WSC3 – Re-Program DME Control Unit (Workshop Campaign)

Revision	Date	Change
0	06/09/2025	▪ Original publication
1	09/26/2025	▪ Addition of California label and certificate

Vehicle Type: **Panamera 4 E-Hybrid (971) / Panamera 4S E-Hybrid (971)**

Proof of Completion Label: specified position (Exemplary illustration)

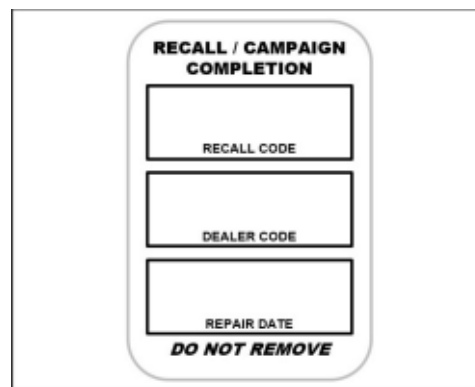
- 5.3 Affix Recall Proof of Completion label in the lower area of the front lid at the lefthand side in direction of travel ⇒ *Proof of Completion Label: specified position (Exemplary illustration) -arrow-*.
- 5.4 Close front lid.
- 6 Enter the campaign in the Warranty and Maintenance Logbook.
